AGENDA
REGULAR MEETING OF THE
PLAN COMMISSION & ZONING BOARD OF APPEALS

Tuesday, May 2, 2023 at 7:00 P.M

PLAN COMMISSION/ZONING BOARD OF APPEALS STAFF REPORT

PLAN COMMISSION/ZONING BOARD OF APPEALS STAFF REPORT

GEWALT-HAMILTON ASSOCIATES, INC.
 MUNICIPAL PLAN REVIEW

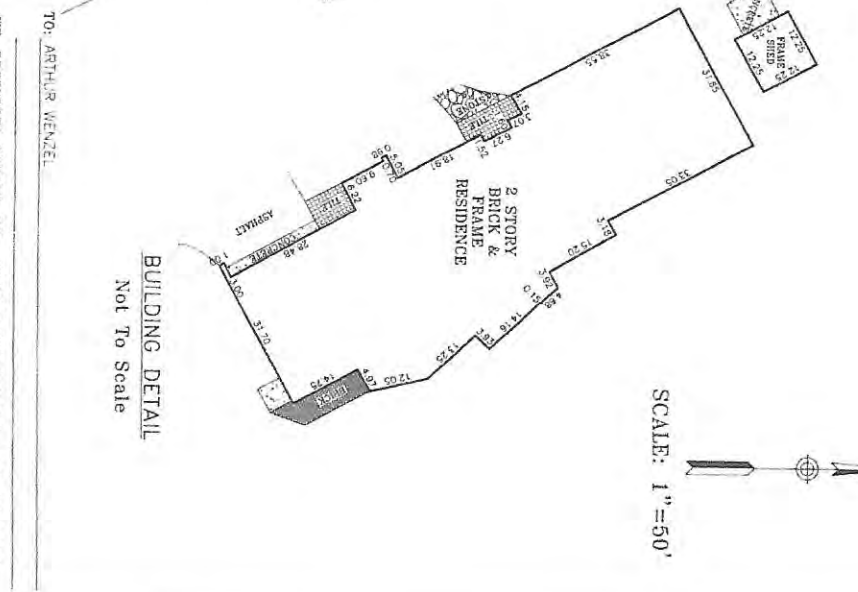
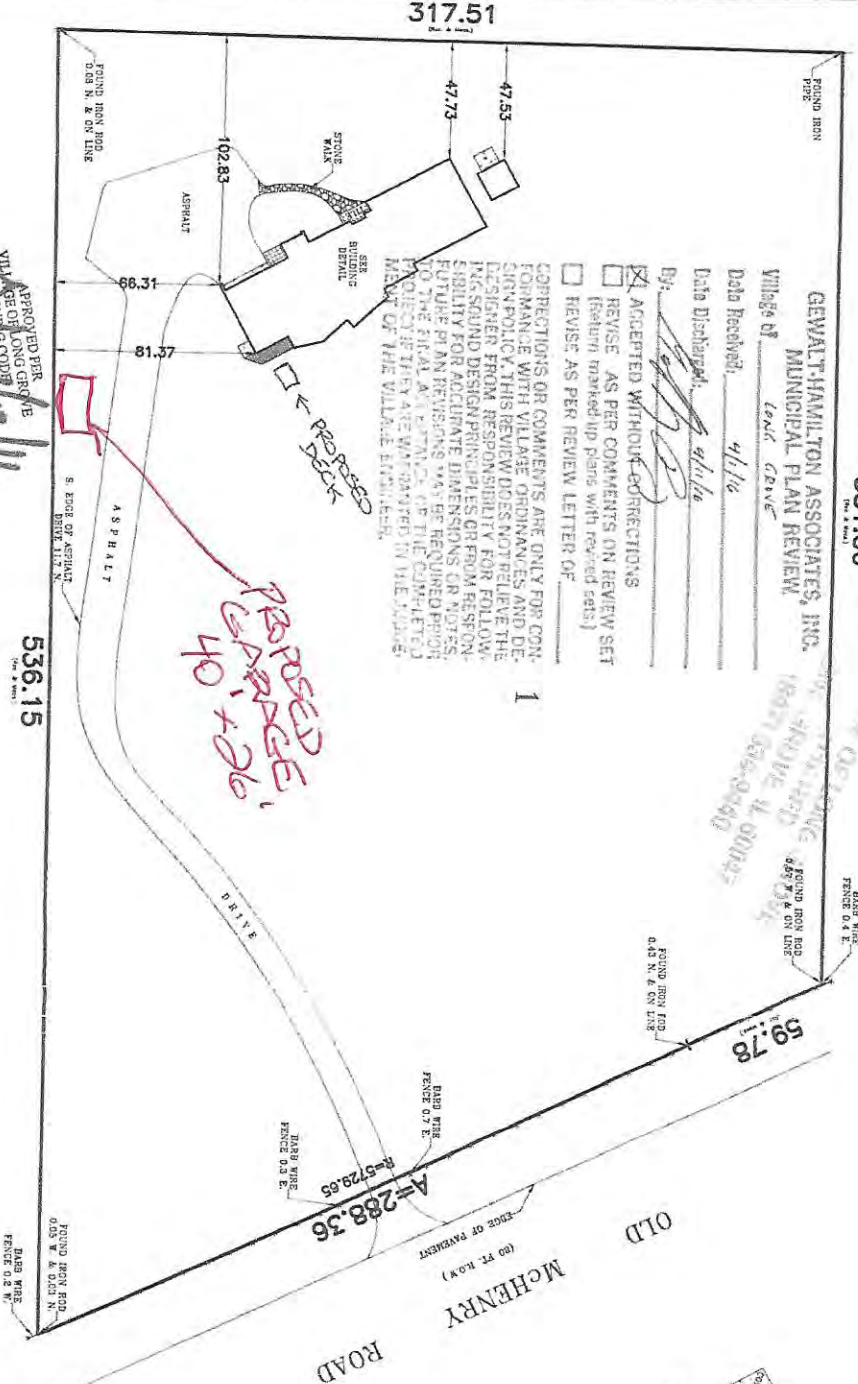
- ACCEPTED WITHOUT CORRECTIONS
- REVISE AS PER COMMENTS ON REVIEW SET (Return marked up plans with revised sets.)
- REVISE AS PER REVIEW LETTER OF _____

Demol Plan

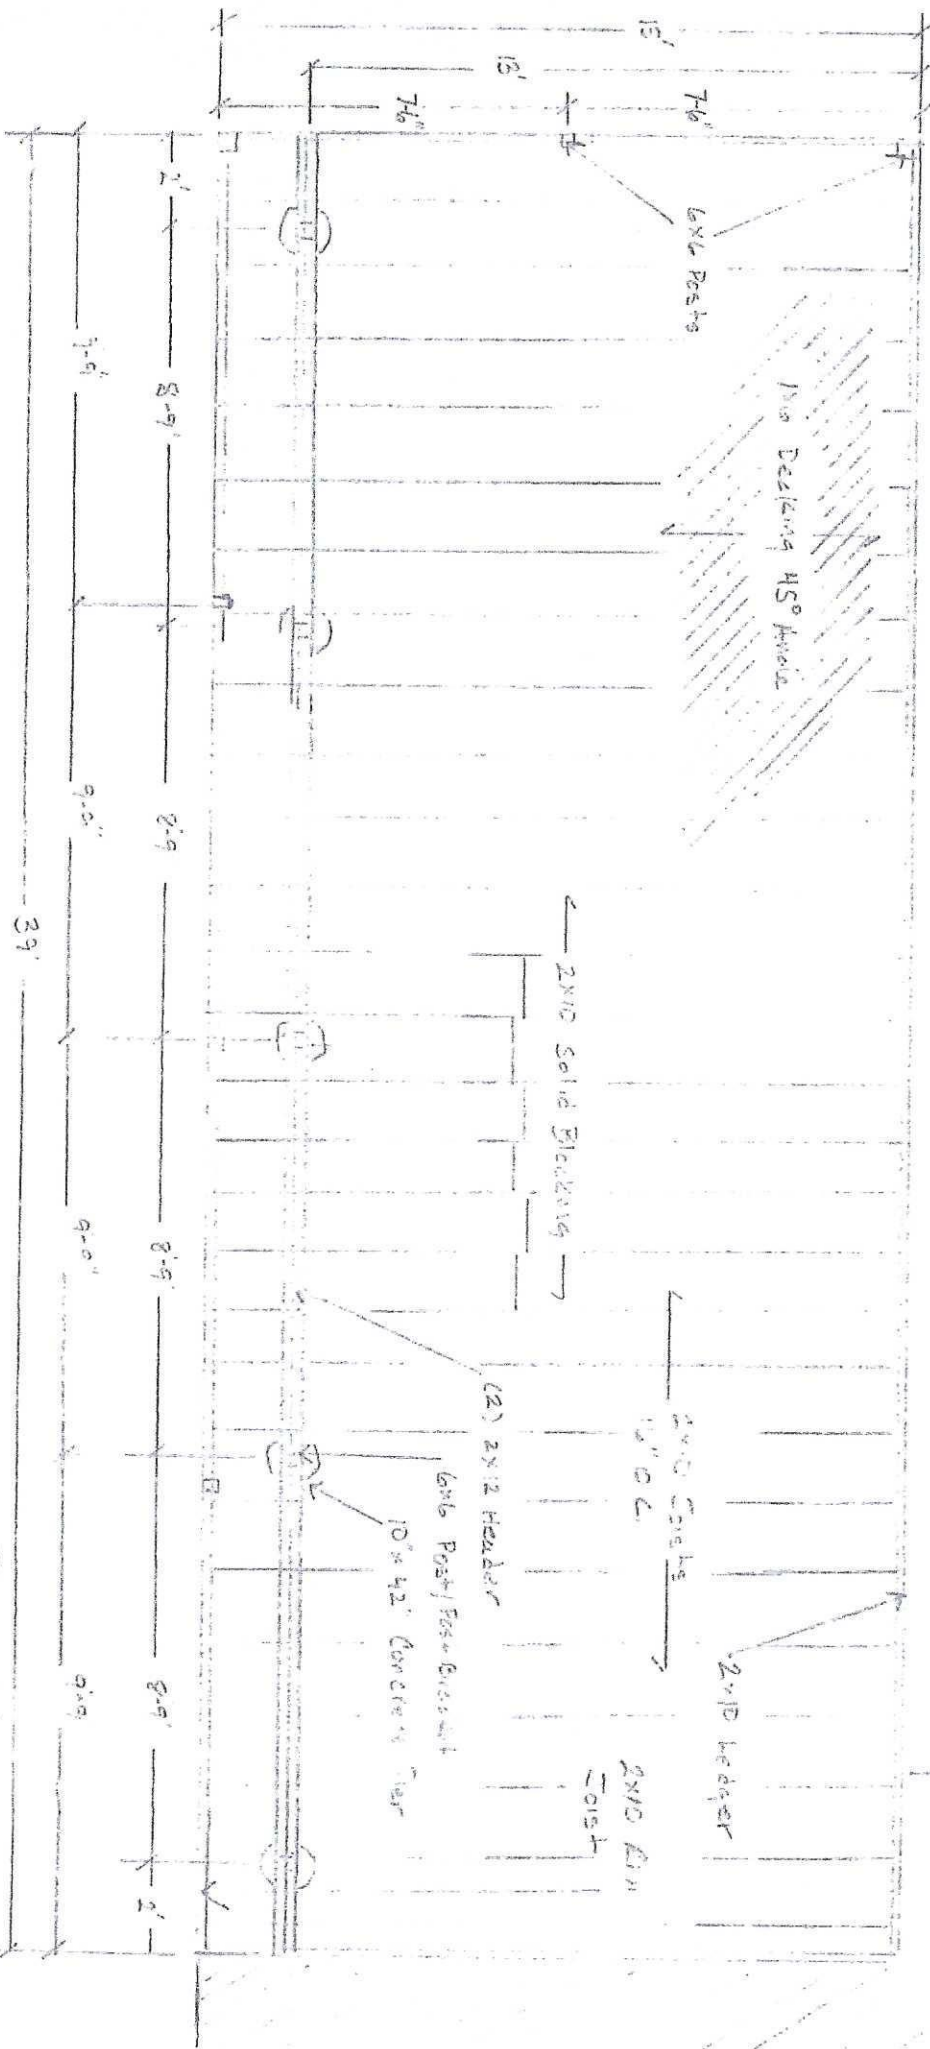
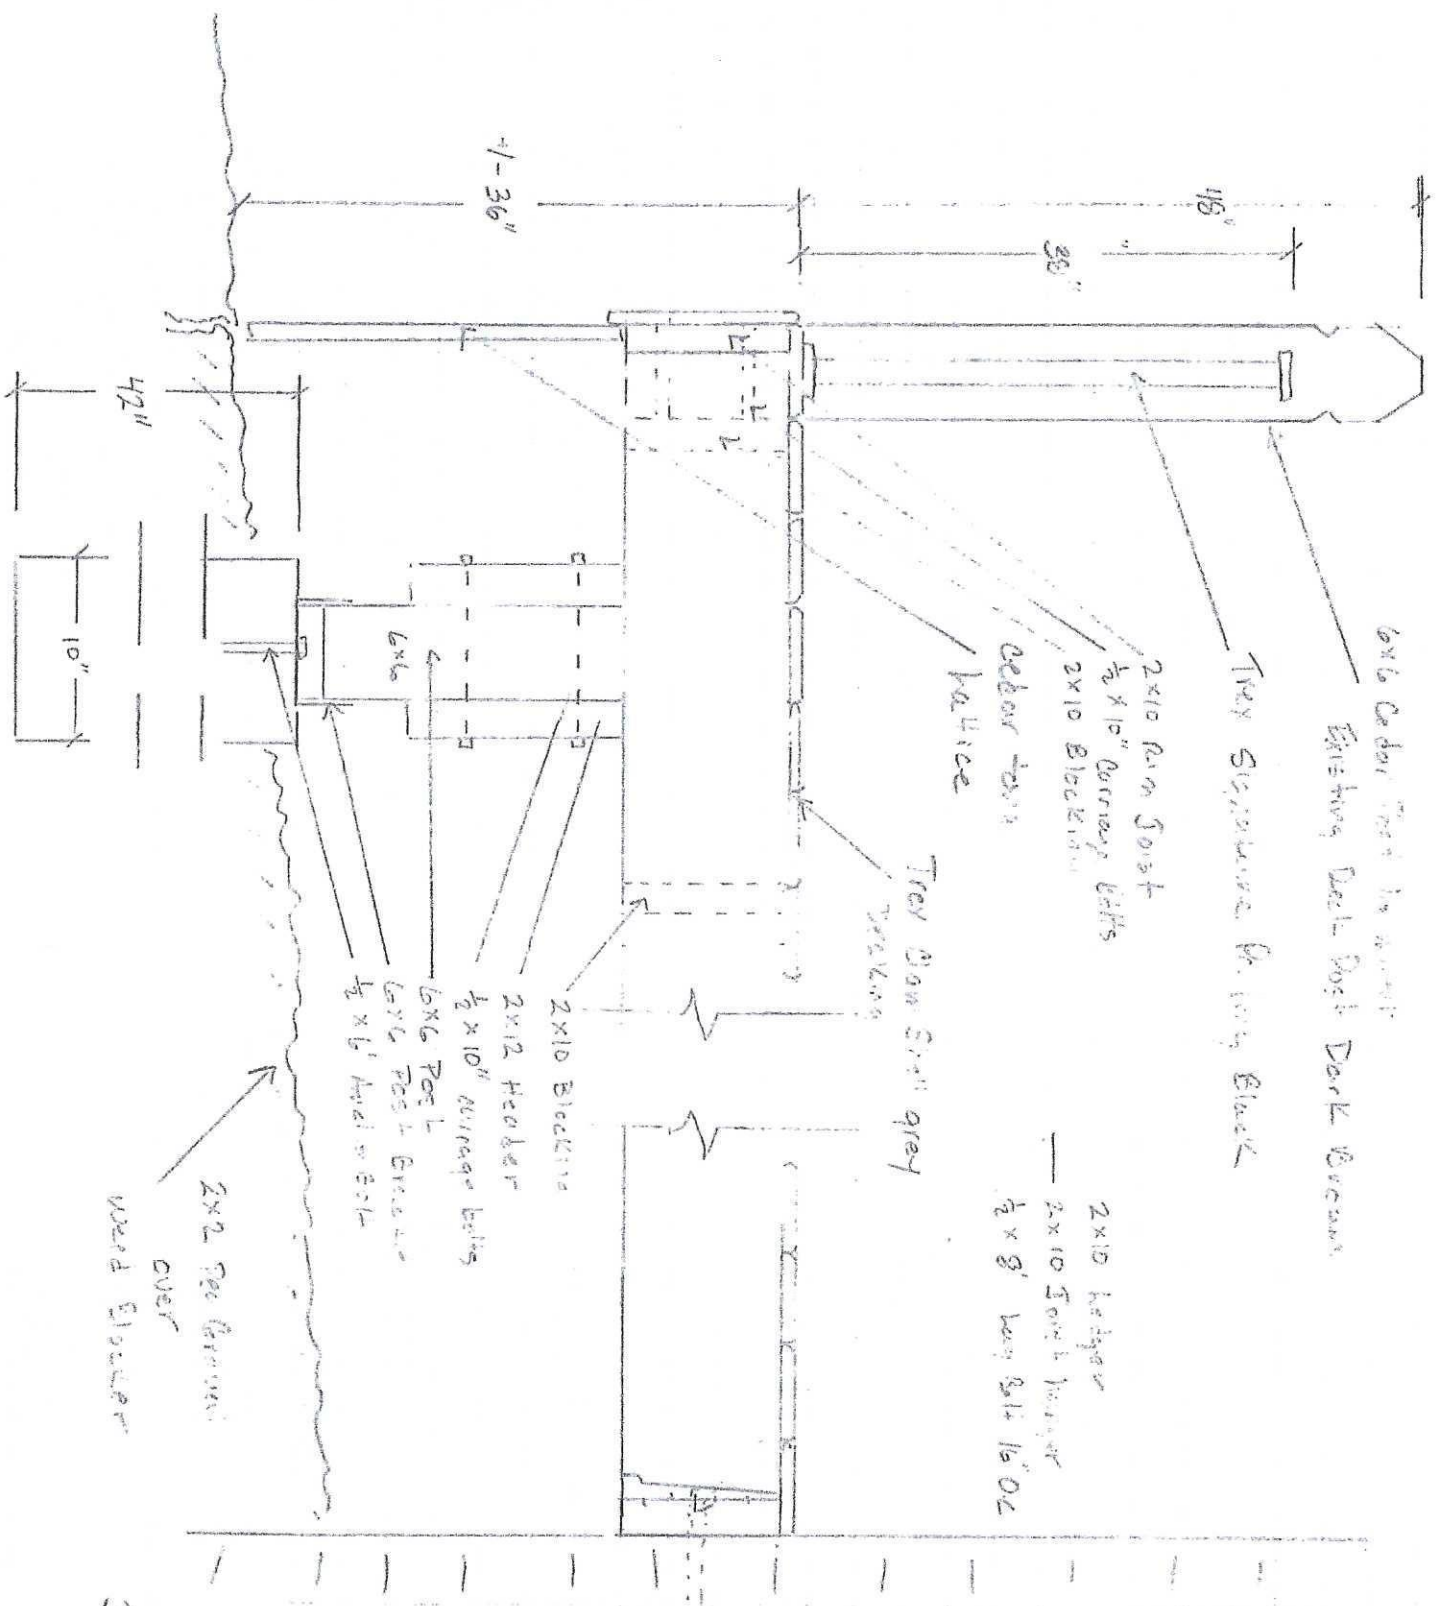
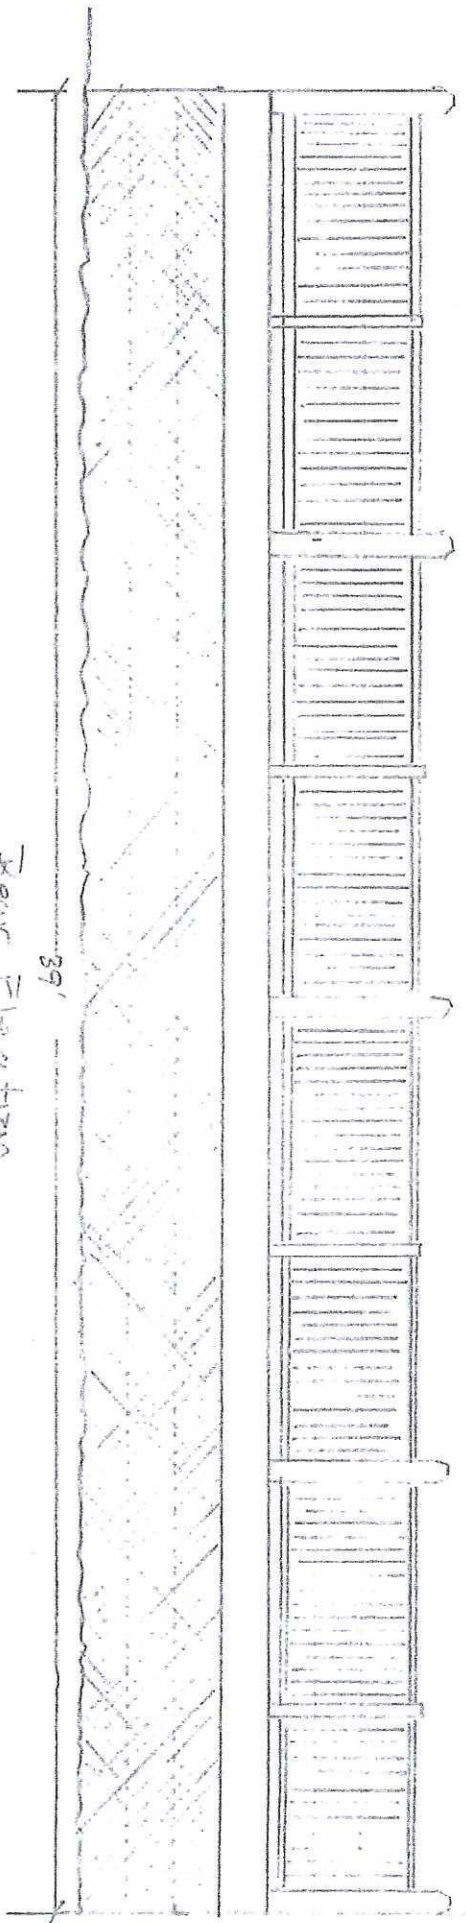
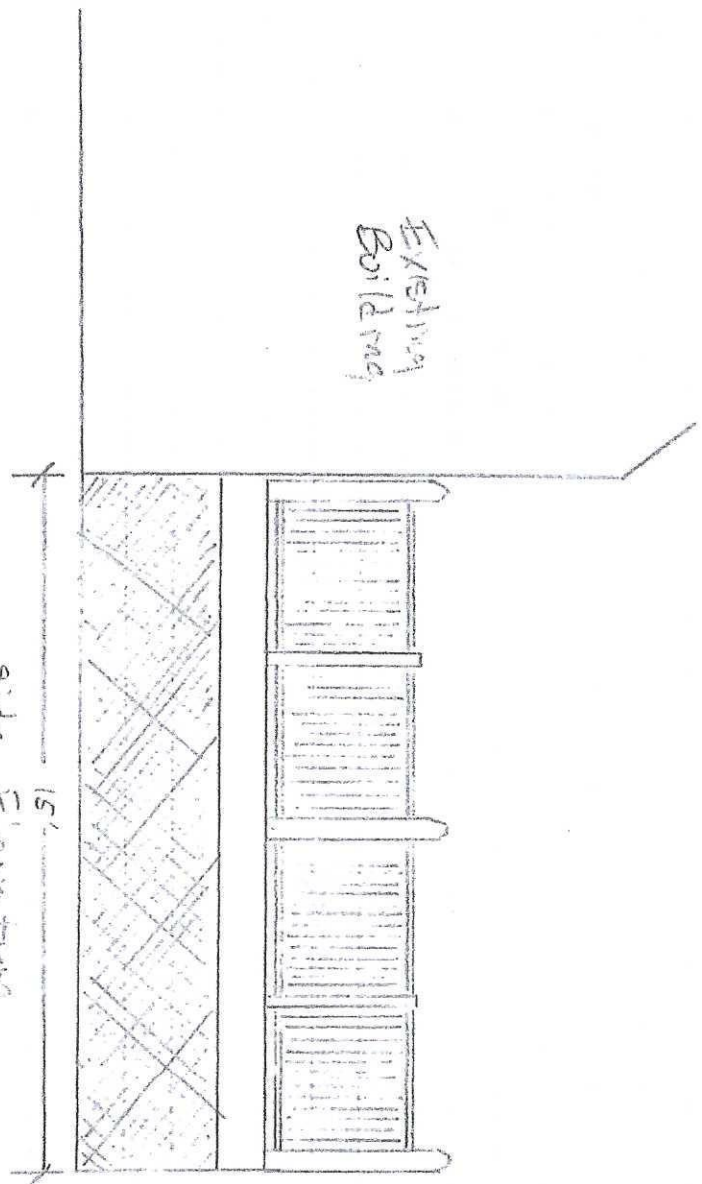
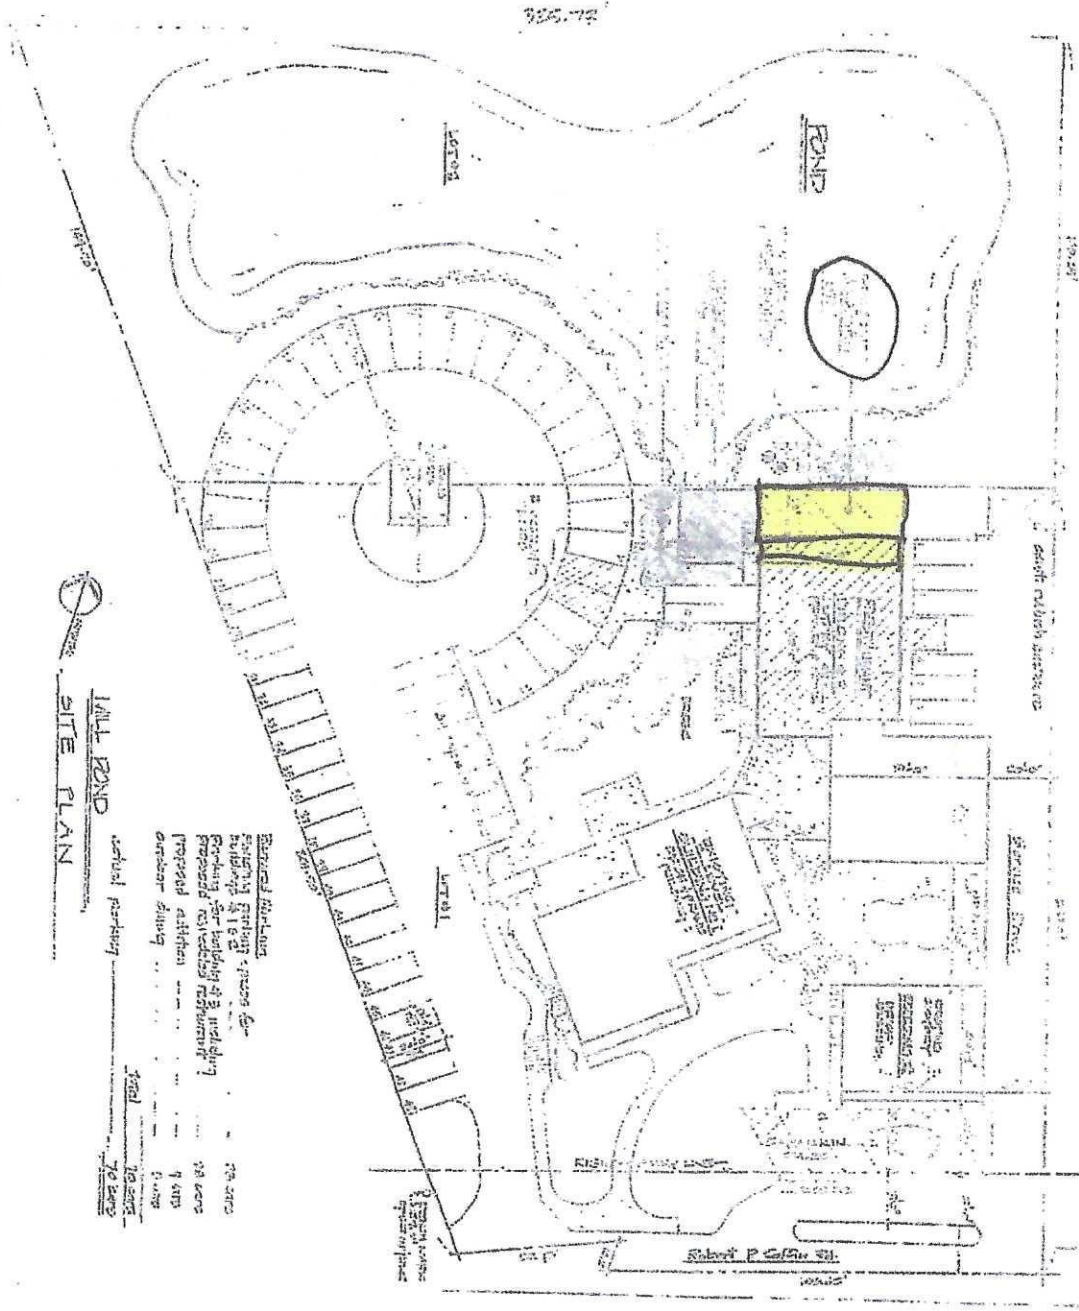
- 1) A Stormwater Permit is required for this activity.
- 2) Silt fence, meeting the Lake County Stormwater Management Commission's standard detail, should be available on site for installation should high erosion control potential occur.
- 3) If the existing electrical outlet, currently located east of the deck, is being relocated this change needs to be added to the plans. Per the Watershed Development Ordinance, it will need to be at least 2-feet above the BFE, which is 712.0.

Building: Permit plans for the deck will need to be drawn by an Illinois Licensed architect as this is a commercial facility and is required by the State of Illinois.
